DEVIATION REQUEST AND DECISION FORM

Project Name : Rolling Meadows/ Bull Hill Phase-1 (Antelope Ridge at Bull Hill)

TRAFFIC DEVIATION EXHIBIT

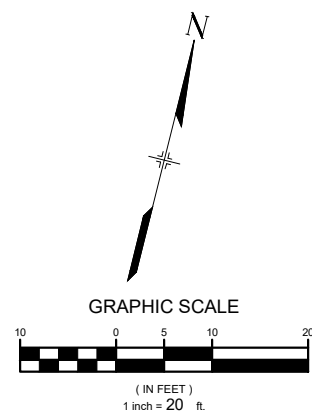
The proposed access drive will be gated with a swing barrier or similar for additional safety and security. There will be no public access or public parking permitted or provided. The swing barrier will be set approximately 60' from the lip of the non-residential collector to allow entering service trucks to be completely free of everyday traffic. (see attached exhibit)

The proposed access drive will be restricted to a 16-foot-wide concrete pad at the ROW where the access drive intersects the non-residential collector. The 16-foot-wide access drive portion and sidewalk, within the ROW, will be constructed of reinforced concrete rated for large heavy-duty vehicles. The access drive outside the ROW shall be gravel construction and may be wider than 16 feet. Additionally, the substation access will utilize rolled (mountable) curb. The rolled curb may begin and extend outside of the 16-foot-wide access restriction to allow for occasional turning movements of the large heavy-duty delivery vehicles. Additionally, road base and non-vegetative landscape materials may be utilized on both sides of the 16-foot-wide concrete access to help stabilize the turning movements of the large heavy-duty delivery vehicles. Details, including autoturn exhibits for the large vehicles, shall be provided with the CD's at the subdivision stage.

This request has been determined to have met the criteria for approval. A deviation from Section 2.3.2 & 2.4.1.B of the ECM is hereby granted based on the justification provided.
